Owner Change Order

Change Order Number: 003

City of Norman - North Base Complex Phase 1
1310-1380 DA Vinci Street
Norman, Oklahoma 73069

The Contract is hereby revised by the following items:

5 ENLARGED ELEC ROOM POWER PLAN - FLEET
ES-01 1/4" = 1'-0"
PLAN NORTH

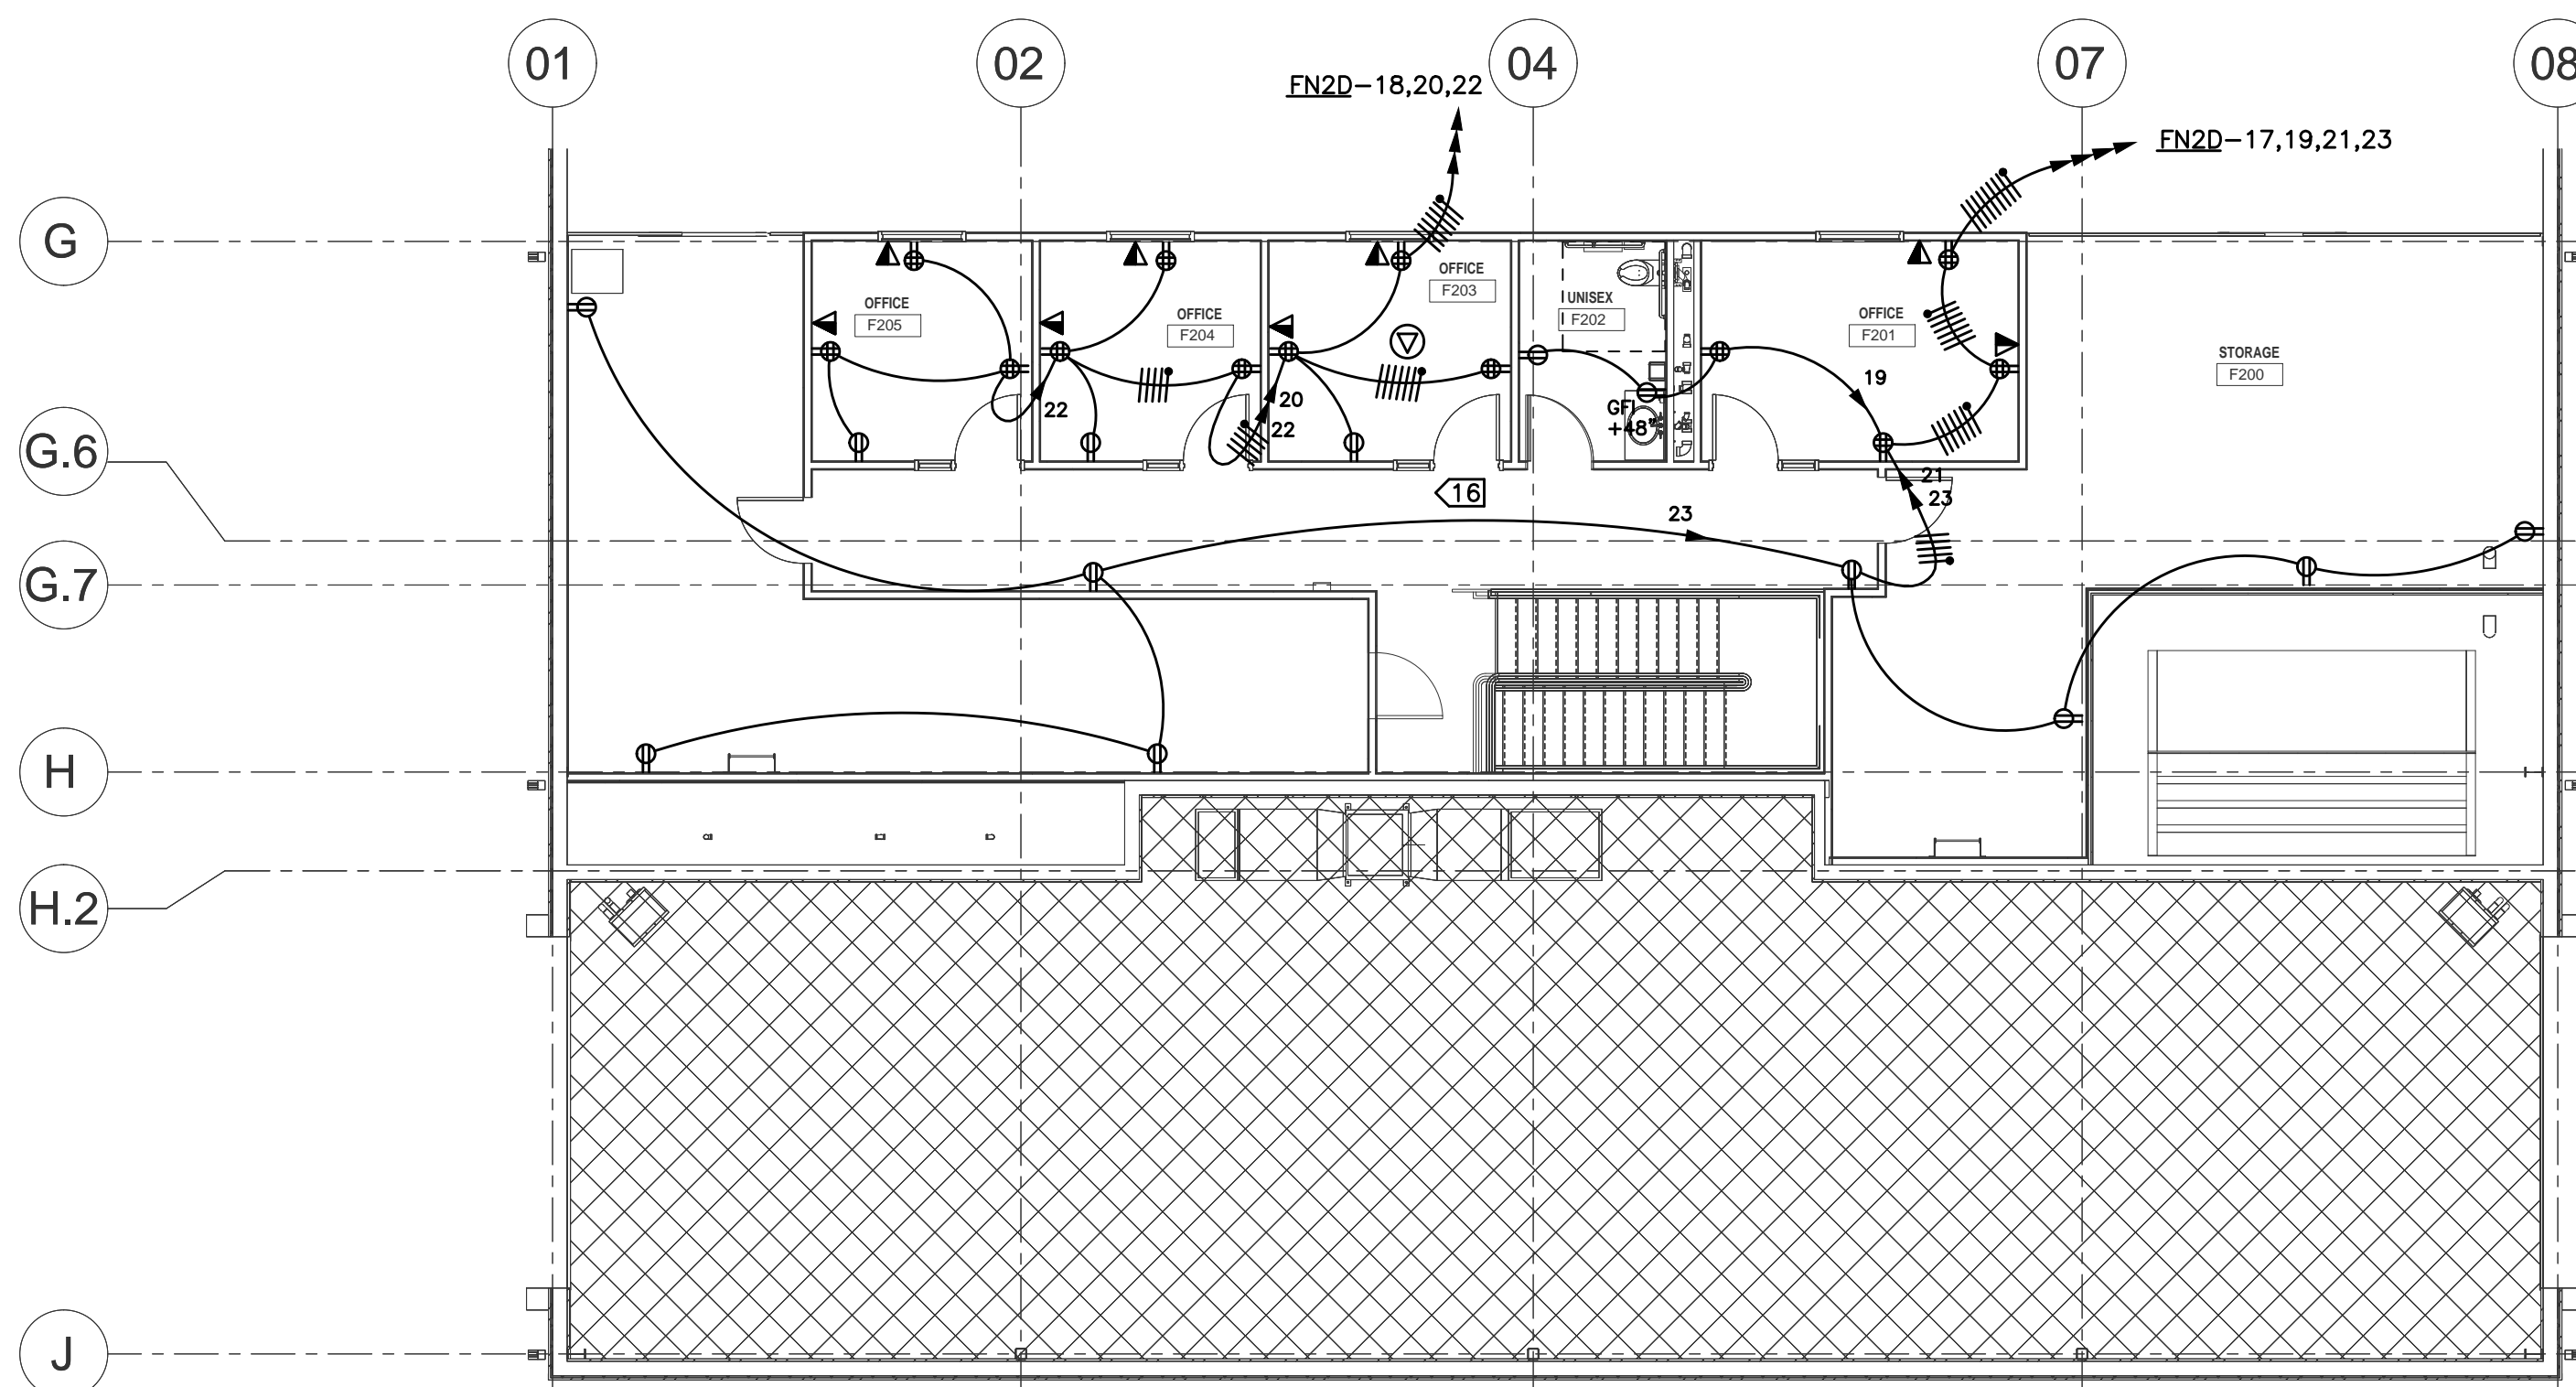
Item	Qty	Unit	Description	Labor Hours	Ext	Material	Ext	Open	Ext
1			added total of 2 tv/power boxes						
2			added 3 GFI receipts in break room						
3			added 3 circuits to brek room						
4			added 1 data rough in lounge						
5									
6	2	e	hubell tv/power rough in boxes			215.00	430.00		
7	2	e	10' sticks of 3/4" emt for data			12.50	25.00		
8									
9	3	e	GFI's			15.00	45.00		
10	7.5	e	10' sticks of 3/4" emt for FN2A 21,23,25			12.50	93.75		
11	1	e	3/4" seal off			25.00	25.00		
12	525	e	75' x 7 of #12 thhn			0.25	131.25		
13	4	e	4sqr boxes			5.00	20.00		
14									
15	1	e	10' stick of 3/4" emt for data rough			12.50	12.50		
16									
17	11	e	11 hours 1 man labor	1	11.00				
18									
19									
20									
21									
22									
23									
24									
25									
26									
27									
28									
29									
30									
31									
32									
Totals				1	11.00		782.50		0.00

DRAWING NO.
A1-00

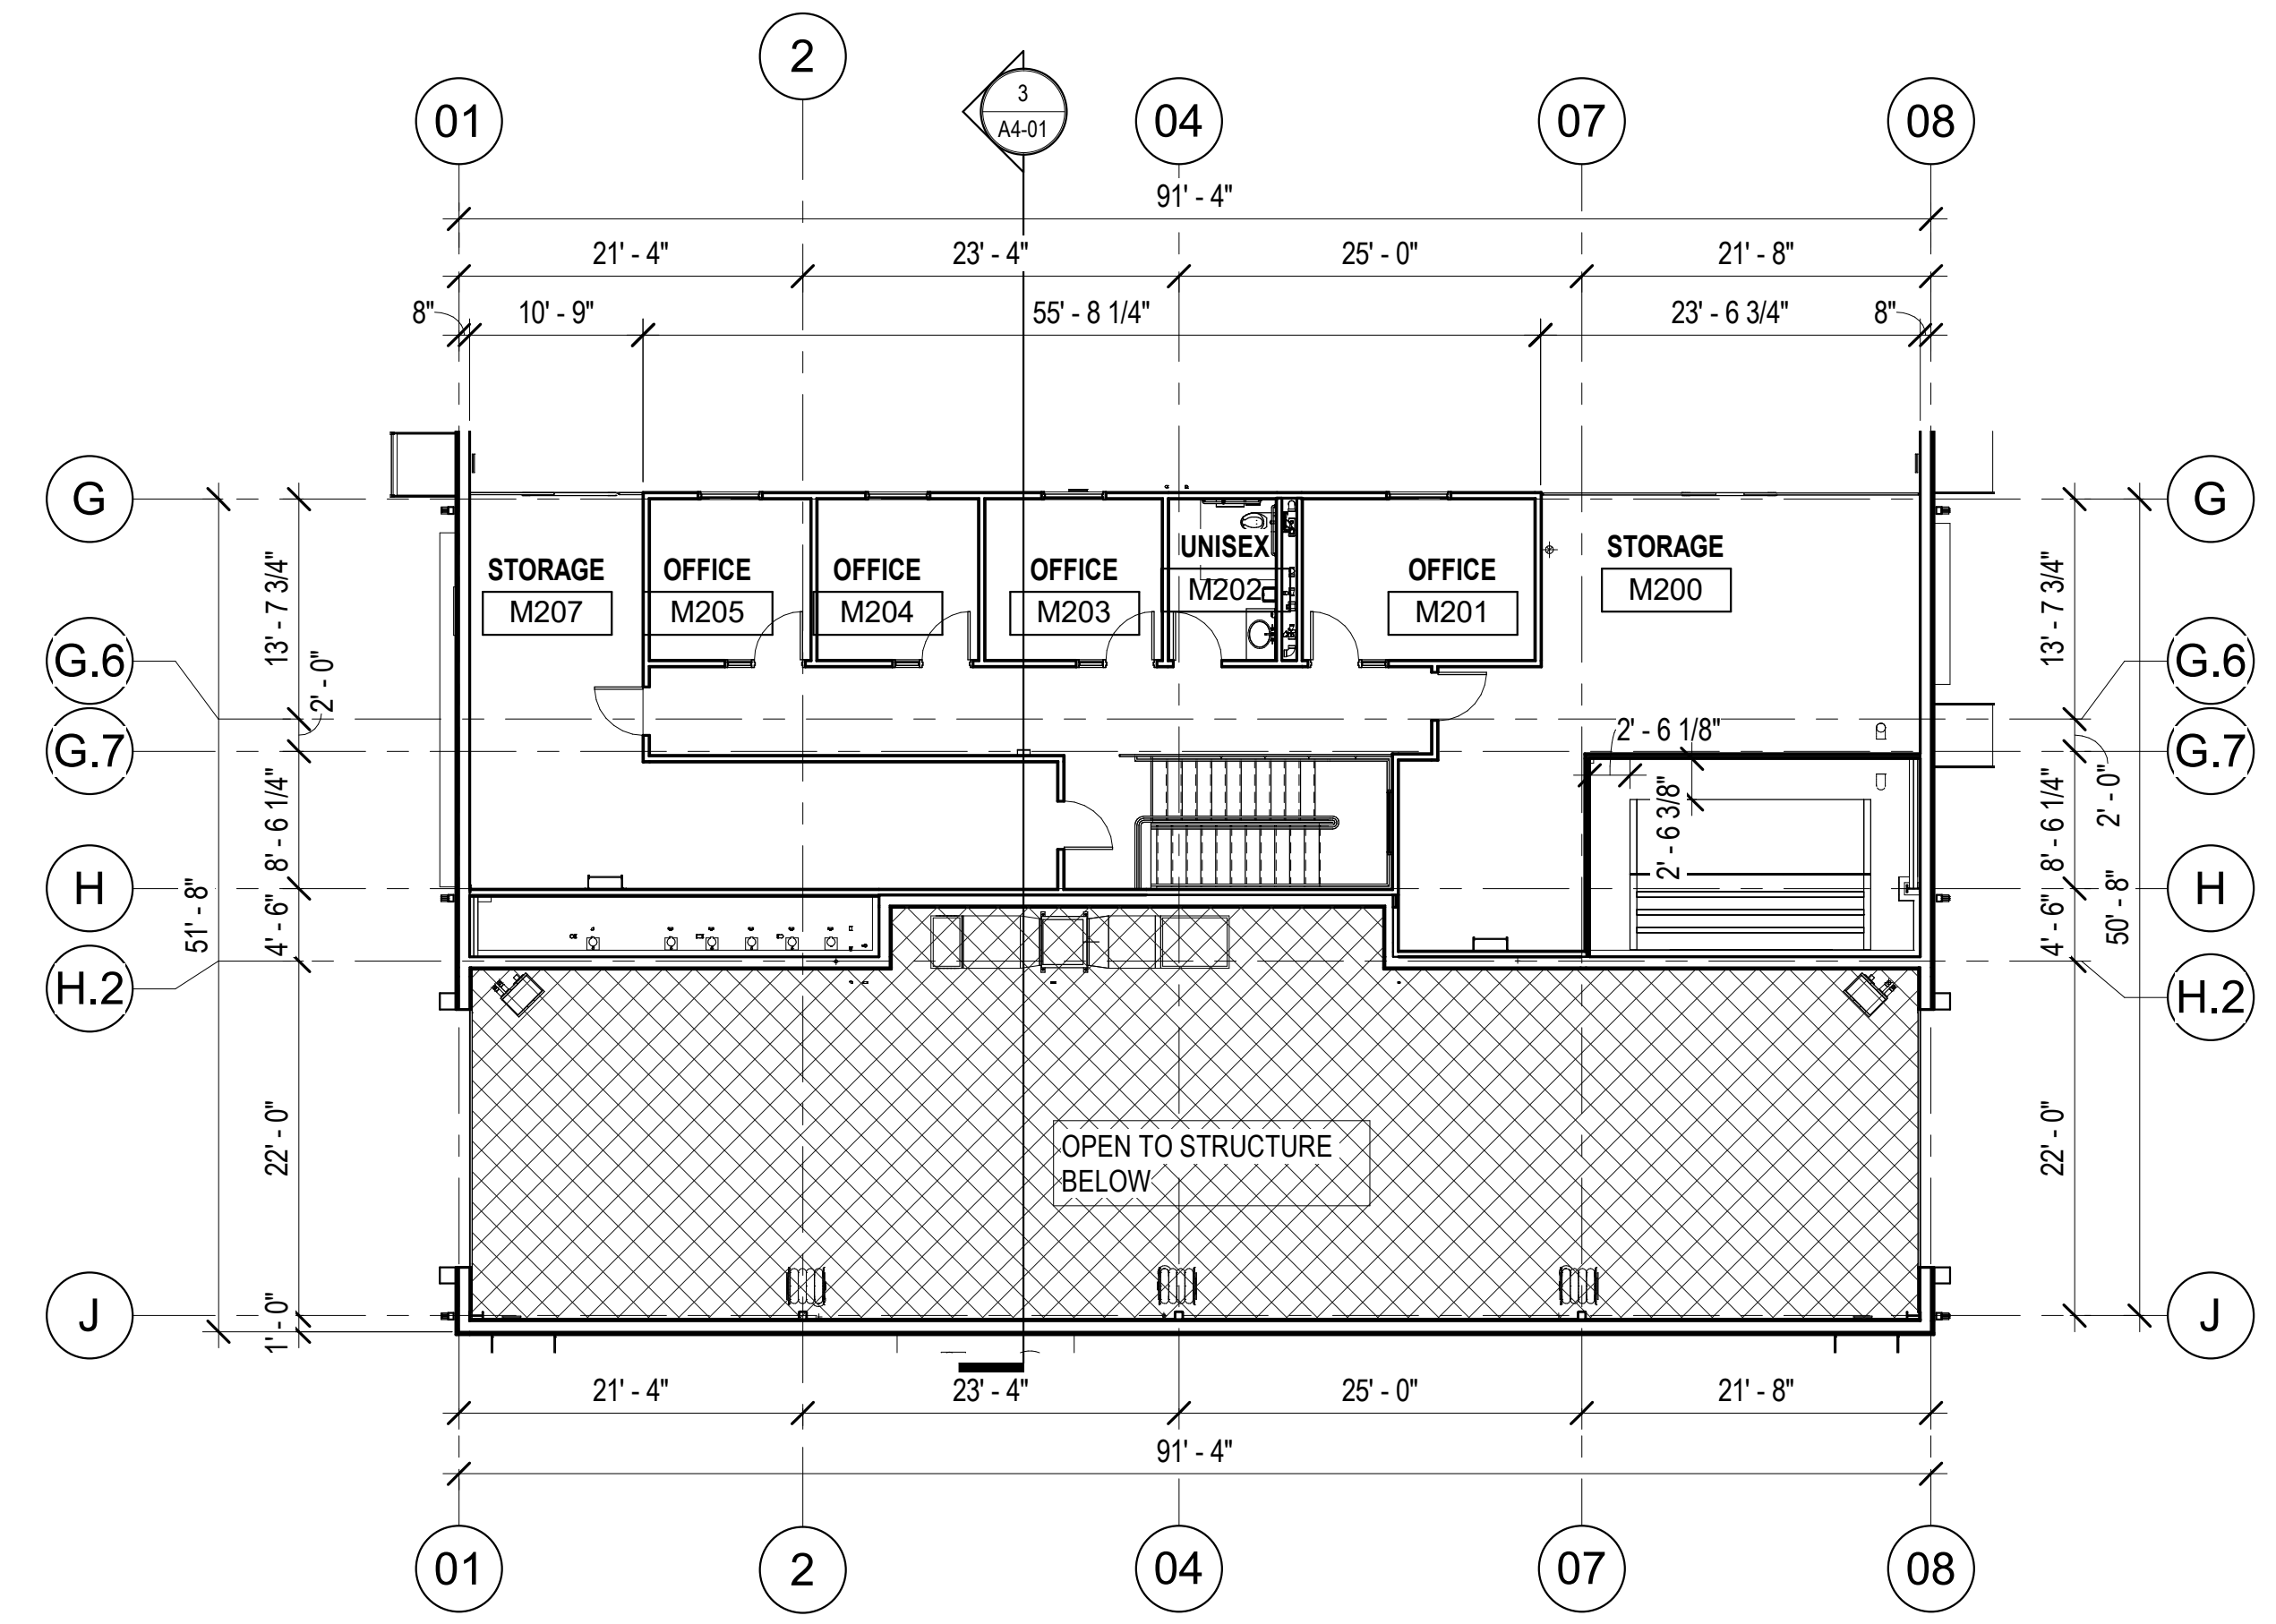
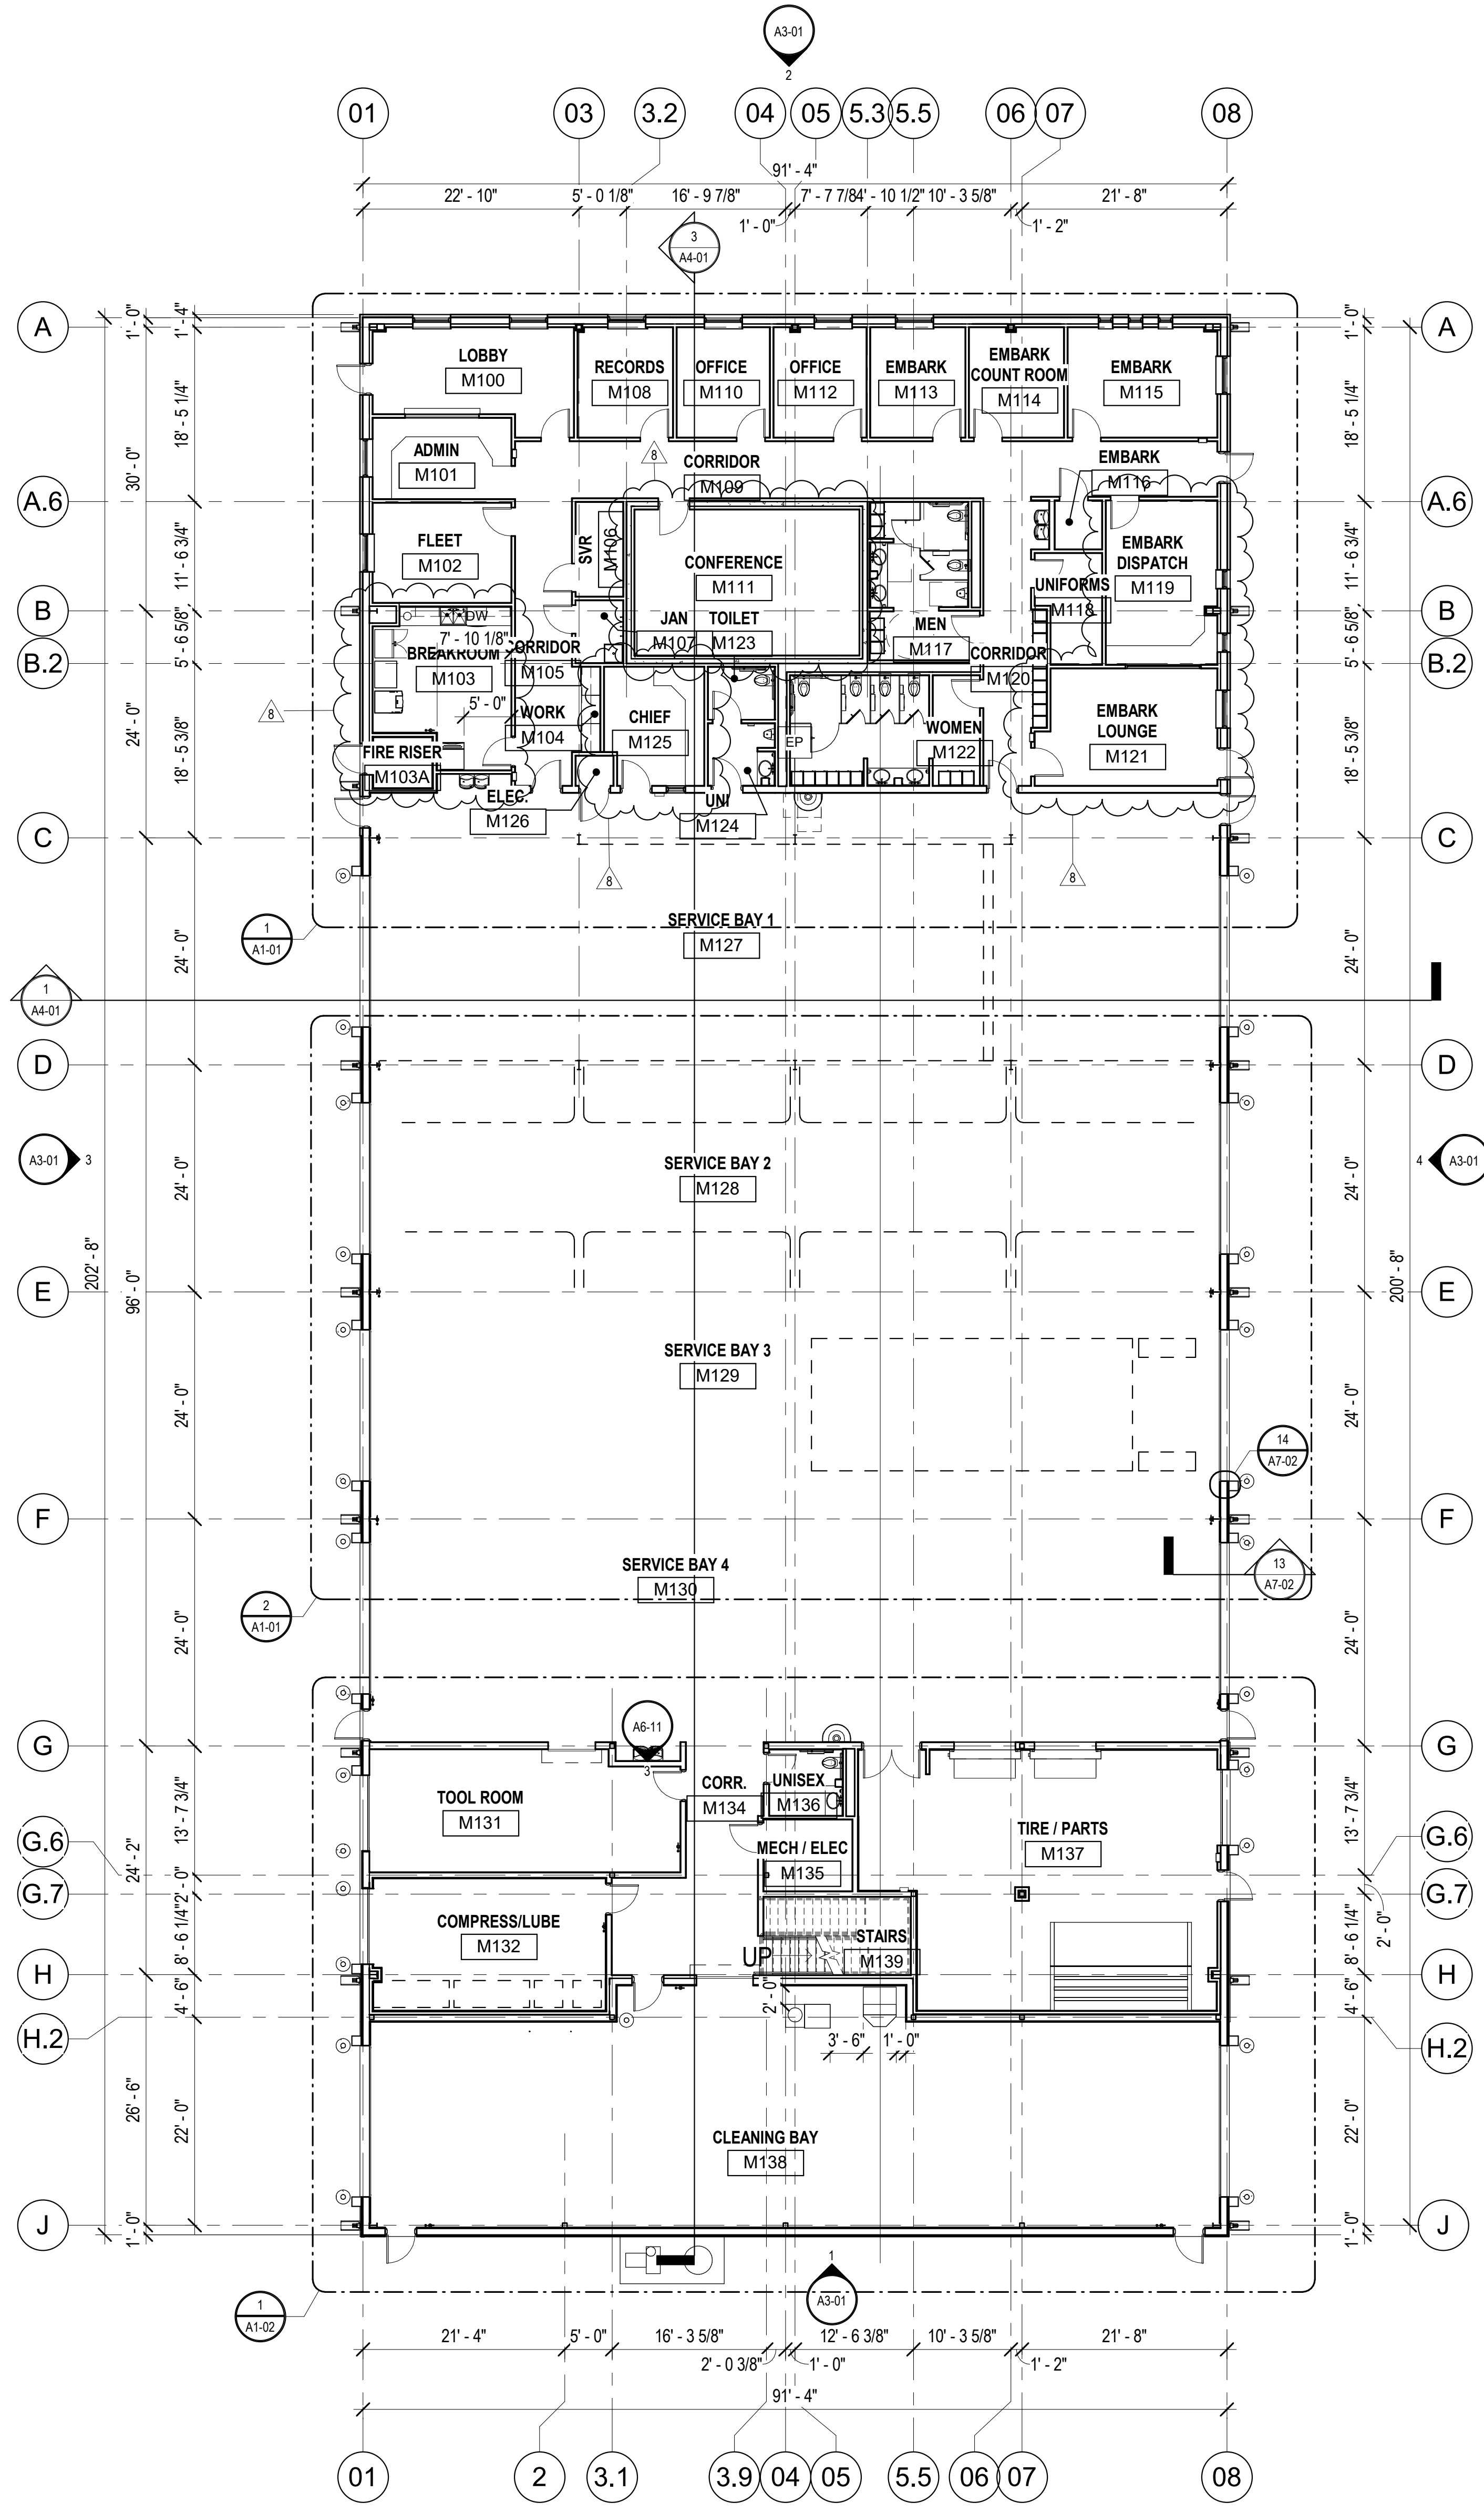
SCOPE:	AMOUNT
08/30/21 - Removed a column to meet a requested dimension in room M103.	\$583
EXCLUSIONS: Overtime or nightwork; MEP; sealing of MEP penetrations; finished wood; millwork; provide or install of doors or door hardware; provide door frames; provide or install of any aluminum doors, door frames or window frames; provide or install of RR accessories; install of fire extinguisher cabinets; mullion caps; glazing; tape & bed; paint; EIFS or stucco; texture; flooring; transition strips; wall tile; blown-in insulation; engineering; any work not mentioned in scope above.	
TOTAL:	\$583
